SERVICE BULLETIN

MODIFICATION AND ALIGNMENT CHECK –ROTOR BRAKE INSTALLATION

All 369H Series Helicopters With P/N 3691190123 Series Rotor Brake Kit Installed

Figure 1. Modification and Clearance Check - Rotor Brake Kit Installation

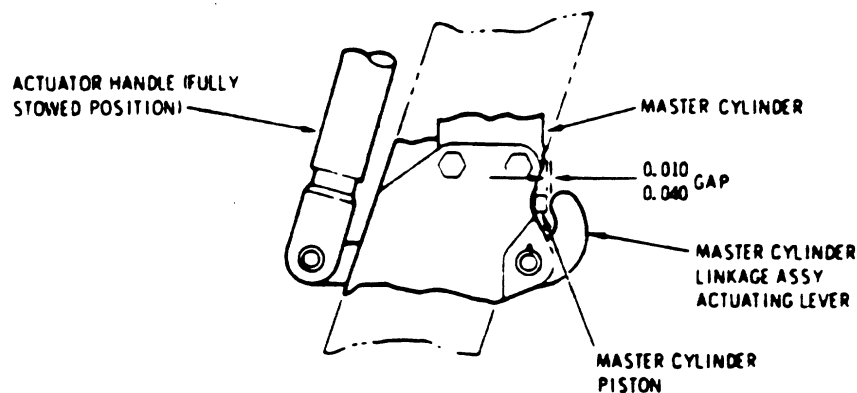
- a. Remove cover from master cylinder actuating assembly.
- b. Using feeler gage, check that 0.010 to 0.040-inch clearance exists between master cylinder piston and actuator lever (See fig. 1).

- c. Remove crew compartment trim panels to gain access to work area and/or prevent damage or soiling.
- d. Remove master cylinder assembly (Refer to HMI App. A, Group 12).
- e. Using drill guide, drill motor and bit, elongate attachment holes of master cylinder mounting bracket, per dimensions shown in Figure 1.

NOTE: The 369H92893 mounting bracket (two attachment holes) is used in current configuration rotor brake kits; the 369H92568 mounting bracket (four attachment holes) is used in early configuration kits.

- f. Coat slotted holes with zinc chromate primer.
- g. Replace existing master cylinder vent tube assembly with new 369A8010-673 vent tube assembly (new vent tube is longer).
- h. Reinstall master cylinder assembly; position cylinder assembly to provide 0.010 to 0.040-inch clearance between master cylinder piston and actuating lever, with lever in fully stowed position.
